ANP-10249NPA  
Revision 1

## ACE/ATRIUM-10 Critical Power Correlation

UNITED STATES  
NUCLEAR REGULATORY COMMISSION  
WASHINGTON, D.C. 20555-0001

SUBJECT: FINAL SAFETY EVALUATION FOR AREVA NP, INC. (AREVA) TOPICAL REPORTS (TR) EMF-2209(P), REVISION 2, ADDENDUM 1, "SPCB ADDITIVE CONSTANTS FOR ATRIUM-10 FUEL" AND ANP-10249 (P), REVISION 0, SUPPLEMENT 1, "ACE ADDITIVE CONSTANTS FOR ATRIUM-10 FUEL" (TAC NOS. MD8754 AND ME0162)

Figure 2.1. 3D Boiling Map

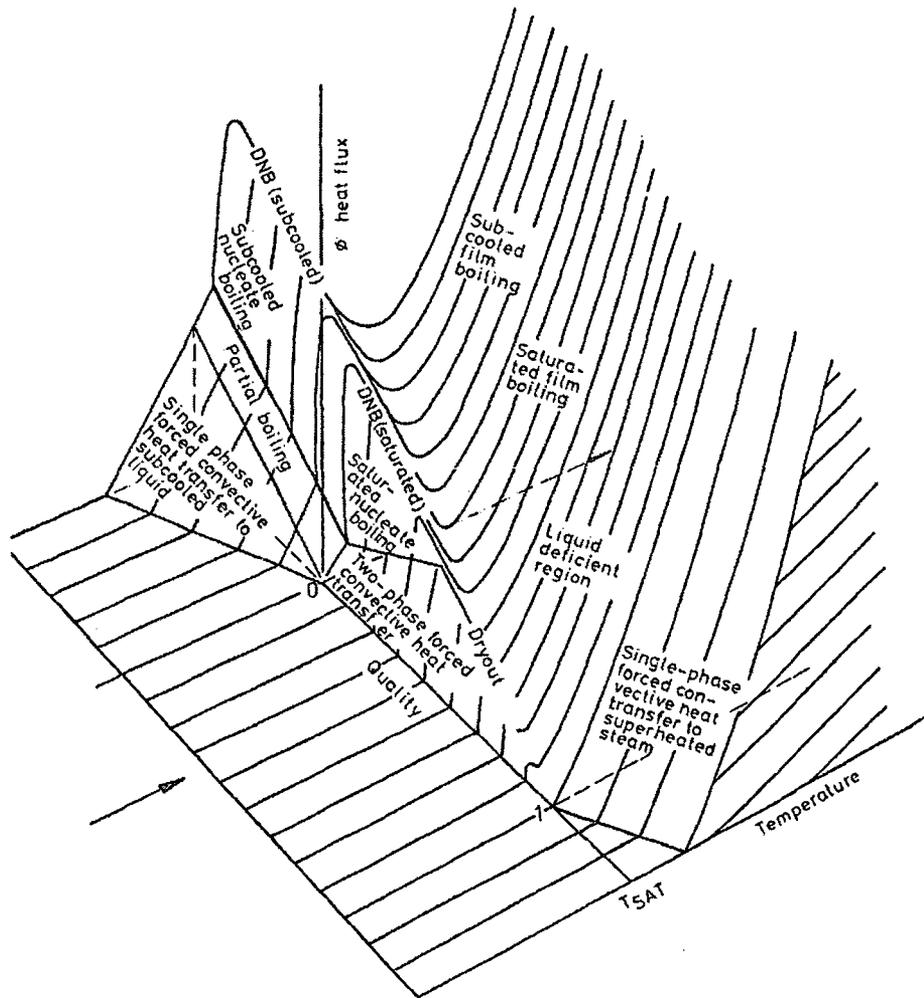
**Question 2. Page 3-3 states that ACE/ATRIUM-10 is a critical power correlation, not a critical heat flux correlation. Nevertheless, for a locally highly peaked heat flux which might result from an off normal reactor condition, local film boiling might result. Discuss how the occurrence of local film boiling will be predicted if it were to occur as a result of an anticipated operational occurrence at a facility using ACE/ATRIUM-10.**

The [ ] provides a complete and adequate representation of BWR dryout. The justification for this conclusion is provided below.

Next, consider the 3D boiling map associated with convective boiling in a vertical heated channel Figure 2.1. This figure portrays the heat flux in terms of the quality and surface temperature. The surface is divided into regions according to the mechanism of heat transfer. Critical heat flux corresponds to the peak in the three dimensional surface at qualities less than 1.0 and temperatures slightly above the saturation temperature. The critical heat flux peak is divided into three parts – critical heat flux associated with subcooled DNB, critical heat flux associated with saturated DNB, and critical heat flux associated with annular flow dryout. It is observed that dryout occurs at higher qualities and DNB occurs at lower qualities and with subcooled boiling. Thus, the question "What conditions are required to achieve DNB?" can be answered by [

**Figure 16.1. Boiling Regime Map**

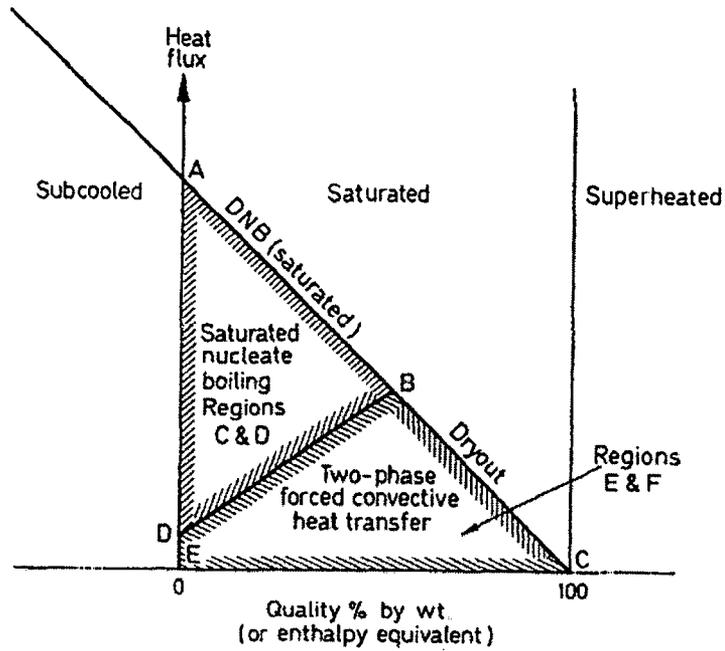
**Question 16. Section 5.7 provides comparisons of ACE/ATRIUM-10 to data from simulated reactor transients. Load rejection and loss of flow events are used in the comparisons. The correlation was found to predict dryout at or before the time of dryout observed in the tests. Please comment on the ability of the correlation to predict dryout times for other types of events which might be evaluated using ACE/ATRIUM-10. In particular none of the tests simulated transients involving reactor depressurization. The staff notes that [**

The load rejection and loss of flow events are the most challenging CPR events in a BWR and these events are therefore the principal CPR limiting events simulated in testing. The character of depressurization events will be discussed from the perspective of [

Consider first the boiling heat transfer and flow regime in relation to critical heat flux, Figure 16.1. This figure provides a map of boiling regime as a function of quality and shows the critical heat flux boundary. For a given state, a decrease in pressure increases the quality. Thus, for a constant heat flux, the state point moves to the right in Figure 16.1. Increasing the quality and moving to the right in Figure 16.1 leads away from nucleate boiling<sup>1</sup> and towards two phase forced convection heat transfer (annular flow regime). The heat transfer is so efficient that it is not possible to achieve the superheat at the rod surface necessary for nucleation.
